Review of "Monitoring and quantifying wind turbine clutter in DWD weather radar measurements"

Author(s): Michael Frech et al. (michael.frech@dwd.de)

MS No.: egusphere-2025-4957

Reviewer: Norman Donaldson, Environment and Climate Change Canada (Ret'd)

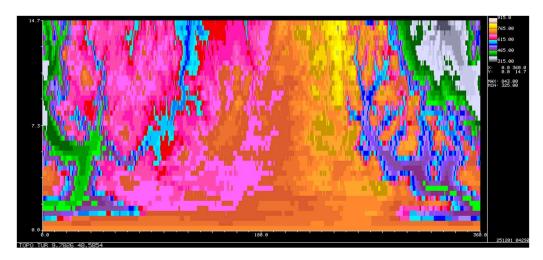
Figure 10: FYI there are four turbines in the north of the wind farm where there are turbine echoes but no crosses. Look near (52.1306N, 11.1613E)\

Coarse view of topography around TUR radar; SRTM30 data (~90m) as B-scan. Yellows are heights above 765m, which 735m ASL ground level at TUR radar plus assumed 30m antenna height. (Relates to Figure 3.)

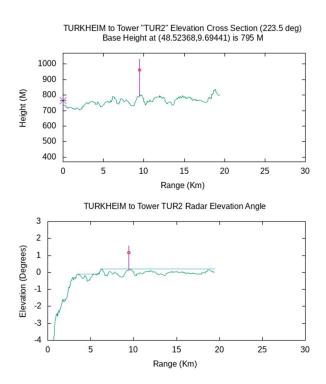
Cross section from radar TUR to turbine "TUR2". Top: topographic height ASL. Bottom: radar elevation angle of topography assuming 30m antenna height. In elevation image the flat lines extend from lowest elevation visible to next visible topography,
